To: Town of Mammoth Lakes Planning and Economic Development Commission,
Commissioners Vanderhurst, Burrows, Chang and Kennedy

Date: May 11, 2022

Subject: Opposition to Villas-III development

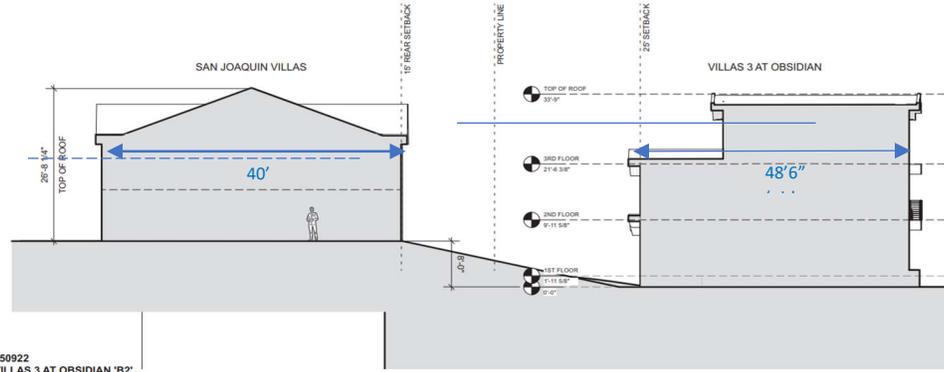
Misrepresenting the facts of the building dimensions/scale (proportion) and incorrect structure locations **invalidates** the applicant's solar analysis.

It is a **conflict of interest** for the applicant to provide a false and biased shadow analysis as an attempt to support their request. It is further disturbing that ToML staff have blindly accepted the contents of this study without fact-checking, *even after* these errors were raised previously, including at as support in the staff report, again shows the bias toward the developer.

It is **essential to require an outside unbiased, independent entity to conduct a true solar study** using **real, factual information** to determine the actual impact this development will have on SJV.

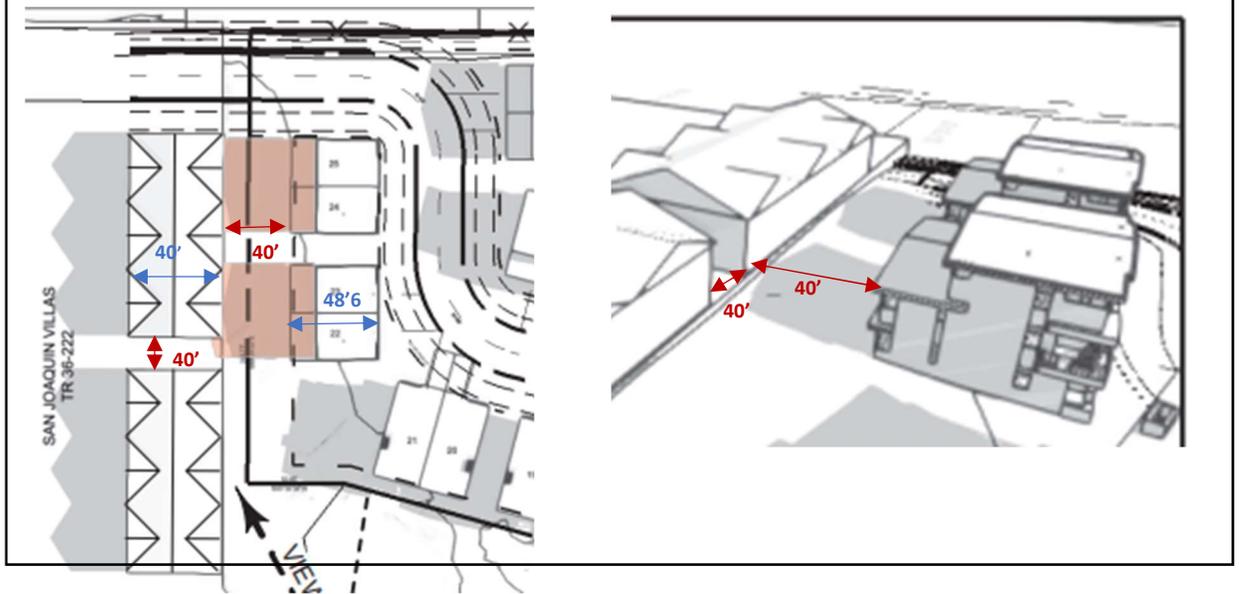
The **distances between buildings** are also misrepresented, as can be seen by the images below with the actual dimensions applied.

- The distance between Villas III and SJV E-building (40’) is shown inaccurately as significantly larger than the distance between SJV’s E- and D-buildings (40’).
- The length of Villas III duplex is longer than the SJV length (40’)

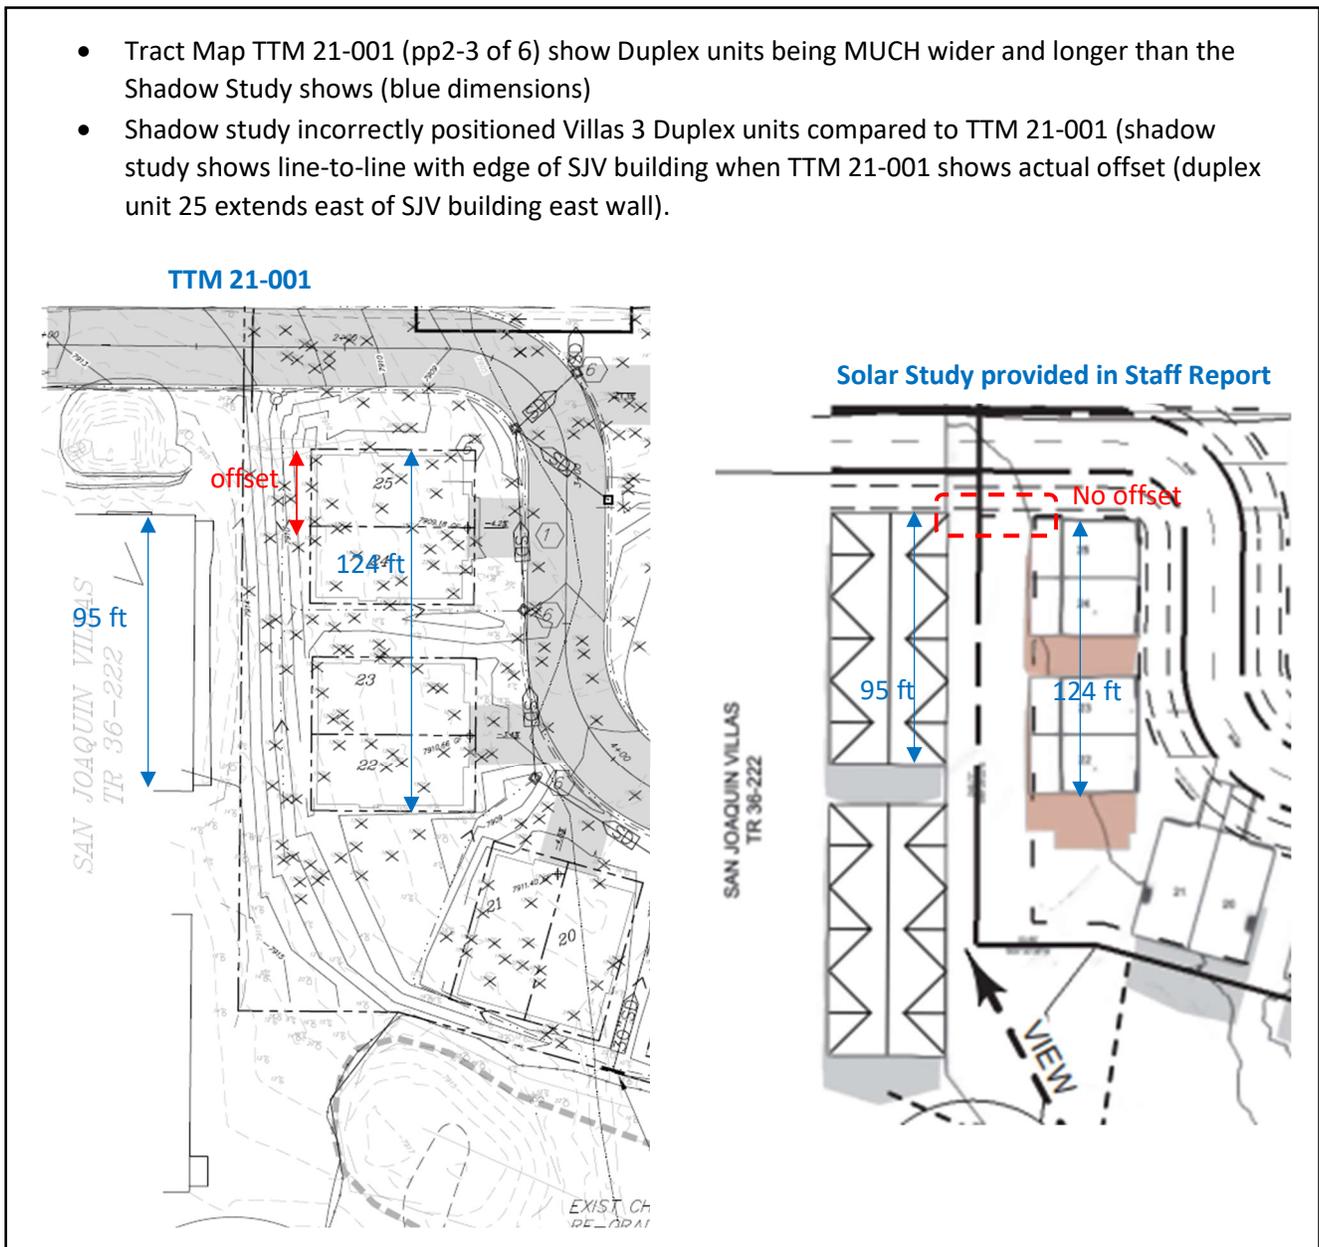
To further illustrate the applicant’s “shadow study” misrepresentation of Villas III duplex proportions, below the Tentative Tract Map TTM 21-001 shows the correct width proportion of Villas III (124’ across

the 2 structures) vs SJV (95') compared to the shadow study which shows these compressed to virtually the same size.

Additionally, the shadow study also misrepresents the location of the two Villas III duplex units. The location discrepancy is easily seen when comparing the position of duplexes 24-25 on the Tentative Tract Map TTM 21-001 vs where these are positioned in the solar study (below, red dotted line).

- Tract Map TTM 21-001 (pp2-3 of 6) show Duplex units being MUCH wider and longer than the Shadow Study shows (blue dimensions)
- Shadow study incorrectly positioned Villas 3 Duplex units compared to TTM 21-001 (shadow study shows line-to-line with edge of SJV building when TTM 21-001 shows actual offset (duplex unit 25 extends east of SJV building east wall)).
